EASTERN PORTAL DEVELOPMENT PLAN

TAS-CYP-EPZ-ZWD-PLA-XLP-MMN-X0001

REV H AMENDMENT – MINISTERIAL SUBMISSION

Table 1 – Amendments to the Eastern Portal Development Plan since Ministerial Approval (01/07/2018)

Figure 1 – Eastern Portal works by CYP and RIA

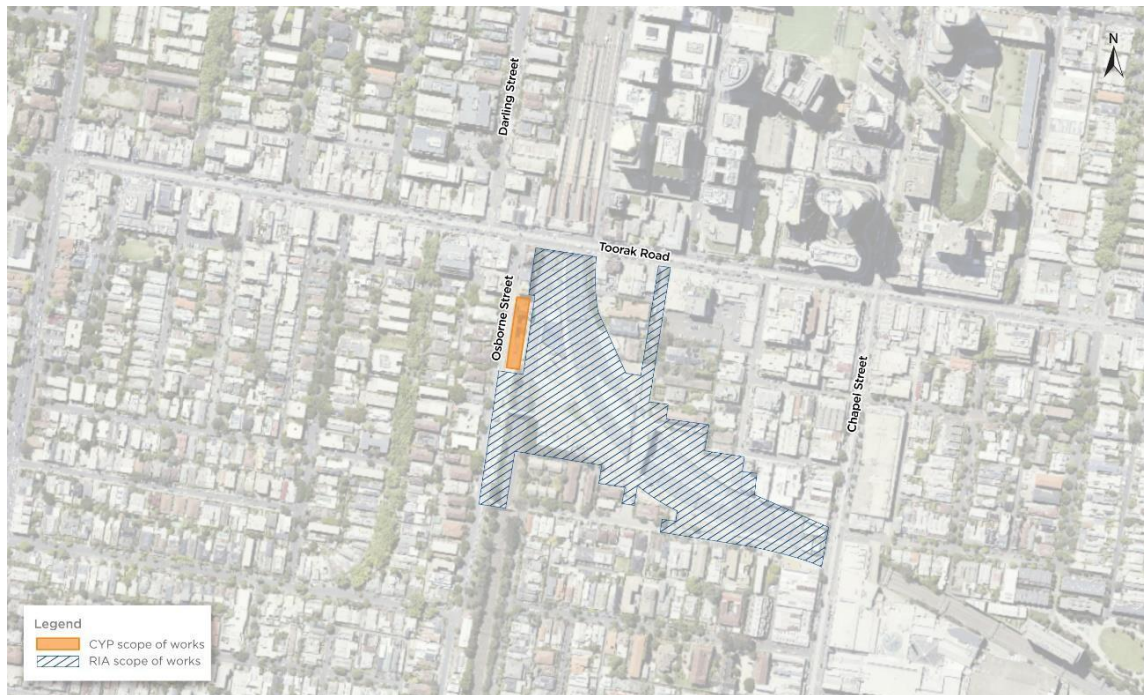
Section	Amendment
Figure 1	Updated to reflect confirmed RIA scope of works
Executive Summary	Updated to mention that the Eastern Portal Development Plan was approved by the Minister for Planning on Sunday 1 July 2018 and that CYP is now seeking an amendment to this Development Plan

Figure 2 – Development Plan consultation process (blue refers to the Early Stakeholder Engagement period, green refers to Stakeholder Engagement during Detailed Design and orange refers to the two Public Display Periods)

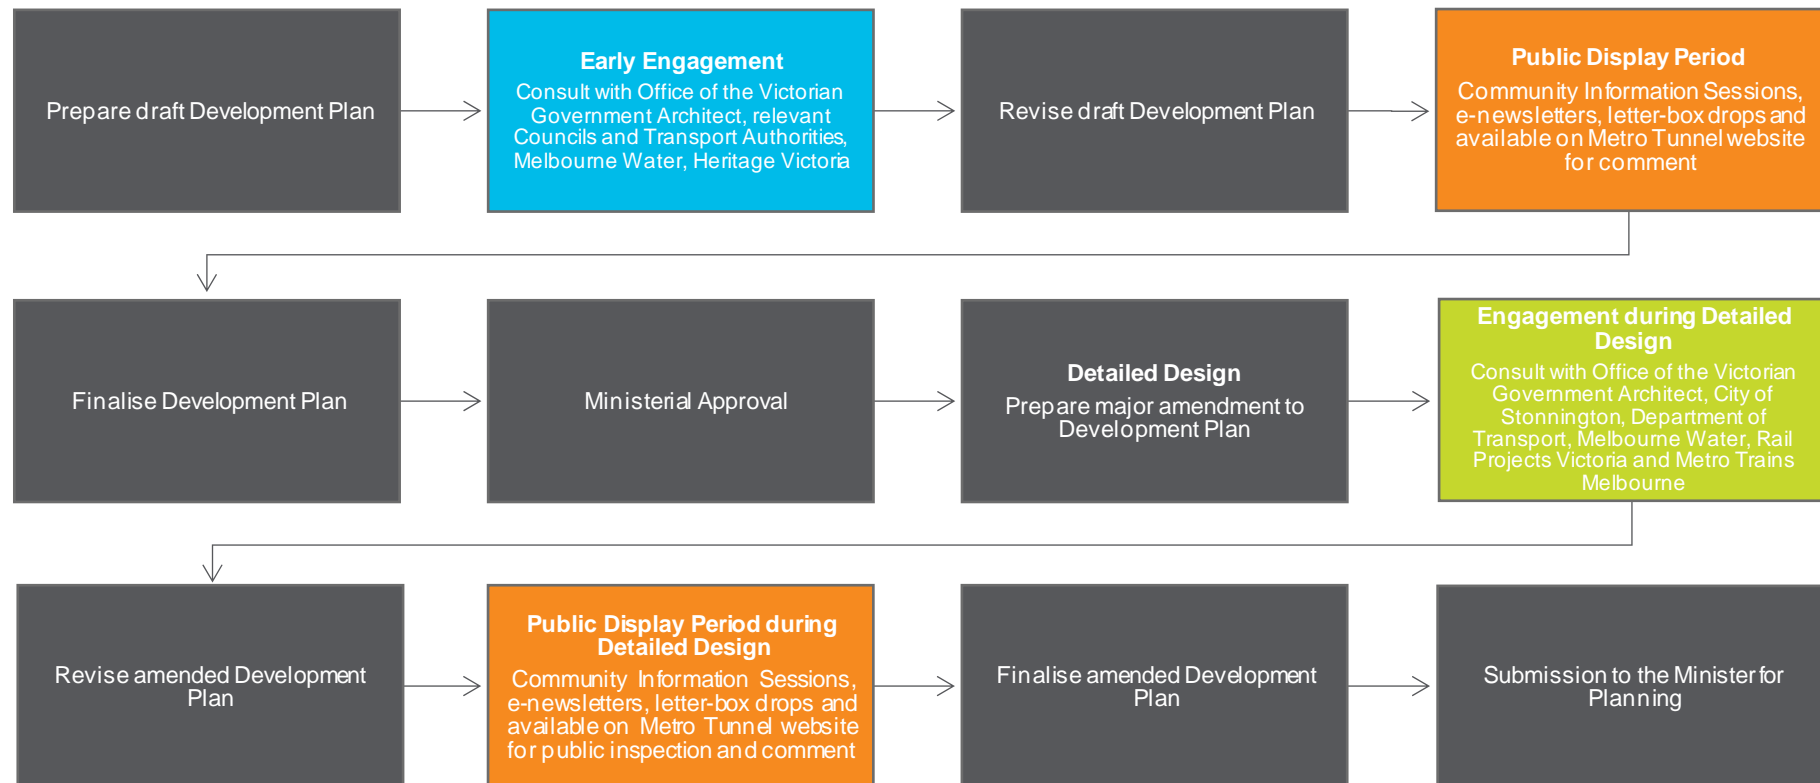
1.3.2. Stakeholder Engagement during detailed design	New section added to outline stakeholder engagement post-Ministerial Approval of the Eastern Portal Development Plan, and during detailed design
Figure 2	Updated to include the additional consultation process post-Ministerial Approval of the Eastern Portal Development Plan

Figure 3 – Scope and extent of built form of CYP's works at Eastern Portal precinct

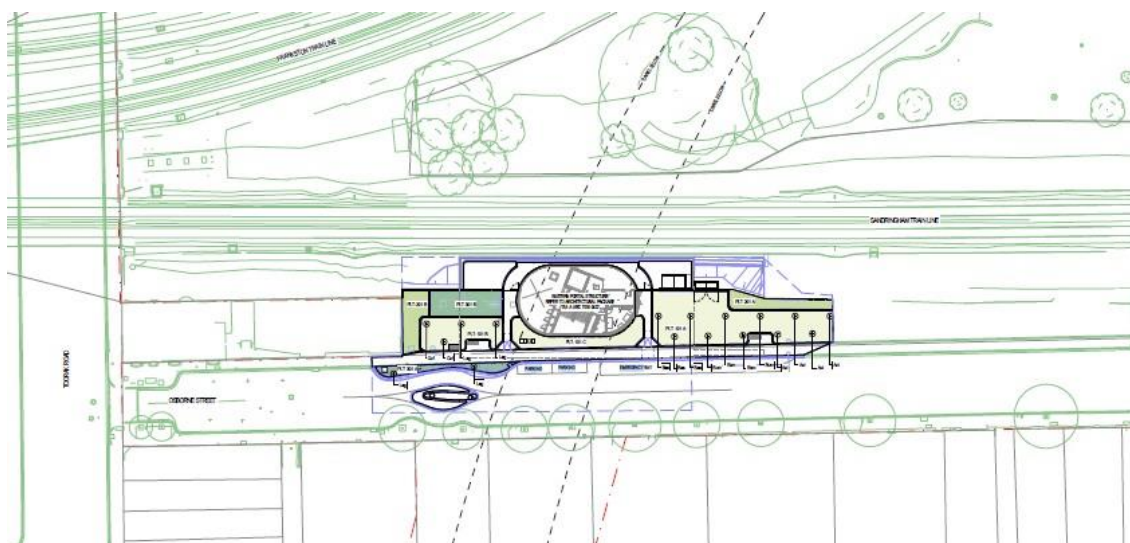
3. Scope of works in Eastern Portal Precinct	Amended to reduce tree removal, with one additional tree retained as a result of design development when compared to the previously approved Eastern Portal Development Plan
Figure 3	Updated to reflect the current Eastern Portal design
Figure 4	Updated to reflect confirmed RIA scope of works
